STUDY OF APPLICABILITY OF RISK REDUCTION MEASURES IN SPATIAL PLANS

Architektonický ateliér Štěpán – Ing.arch. Václav Štěpán

Version 05/2020

II. Part 2 – pilot locality of Lipí and proposed changes to area planning documentation

Place for solving SI-8 and SI-9 (village Vrábče, cadastral area Slavče):

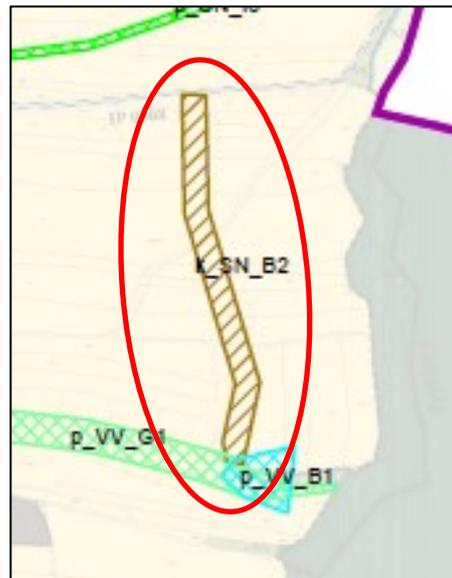
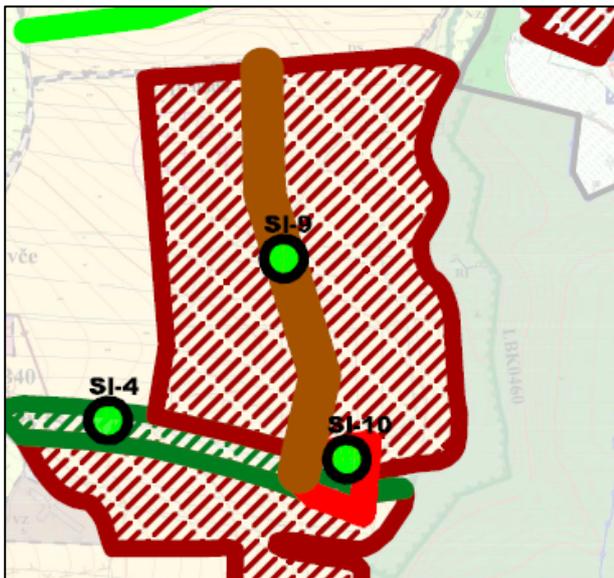
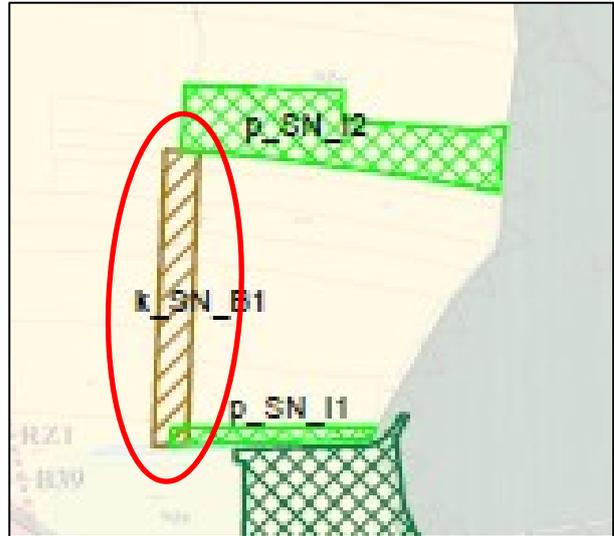
On the territory of the Vrábče zoning plan included in the agricultural areas, the T. G. Masaryk Water Research Institute proposed the implementation of a protective measure in the form of an anti-erosion limit to ensure flood protection. The author of this study, after assessing the area, agreed with the VÚV proposal, and therefore a mixed corridor of a mixed undeveloped area – a field border (k_SN_B1 and k_SN_B2) is proposed for the implementation of the protection measure in question in the amendment of the zoning plan.

Place for solution SI-10 (village Vrábče, cadastral area Slavče):

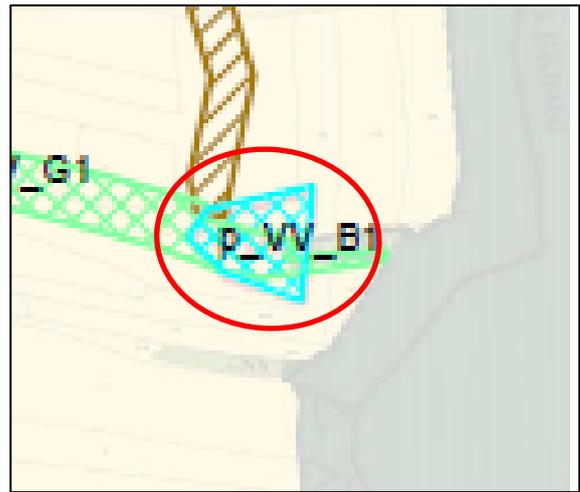
On the territory of the Vrábče zoning plan included in the agricultural areas, the T. G. Masaryk Water Research Institute proposed the implementation of a protective measure in the form of a small water reservoir to ensure flood protection. The developer of this study, after assessing the area, agreed with the VÚV proposal, and therefore a water and water management area - a small water reservoir (p_VV_B1) is proposed in the change of the zoning plan for the implementation of the protective measure in question.

Place for solution V-4 (village Vrábče, cadastral area Vrábče):

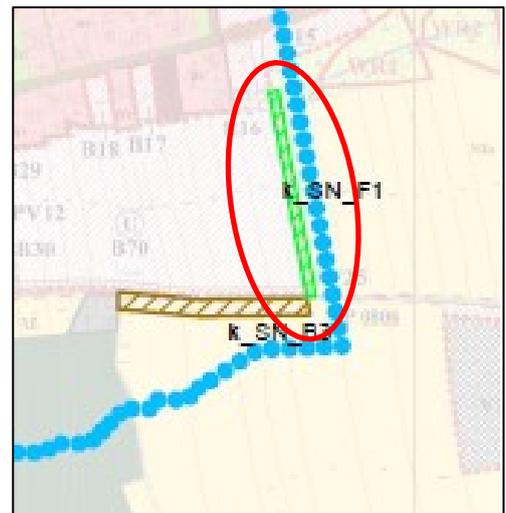
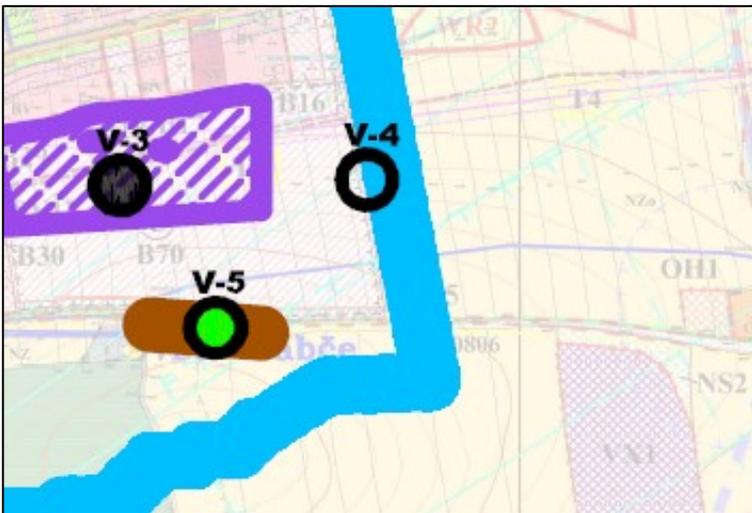
In the area of the Vrábče zoning plan included among agricultural areas, measures to ensure flood protection in the form of a drainage ditch were added. After assessing the area, the author of this study decided to supplement the site in the change of the zoning plan with a mixed undeveloped area corridor – a ditch (k_SN_F1), which will help better drainage of water from adjacent fields and prevent water from torrential rains.

Place for solution V-5 (village Vrábče, cadastral area Vrábče):

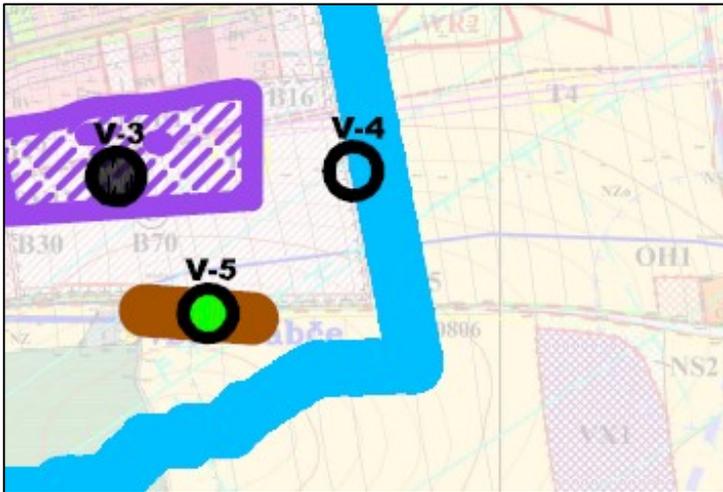
On the territory of the Vrábče zoning plan included in the agricultural areas, the T. G. Masaryk Water Research Institute proposed the implementation of a protective measure in the form of an anti-erosion limit to ensure flood protection. The developer of this study, after assessing the area, agreed with the VÚV proposal, and therefore a mixed corridor of a mixed undeveloped area – a field border (k_SN_B3) is proposed in the amendment of the zoning plan for the implementation of the protection measure in question. This corridor is extended compared to the original design of the VÚV, based on the connection to the newly designed flood ditch (k_SN_F1) and the addition of the overall solution of flood protection measures in this locality.
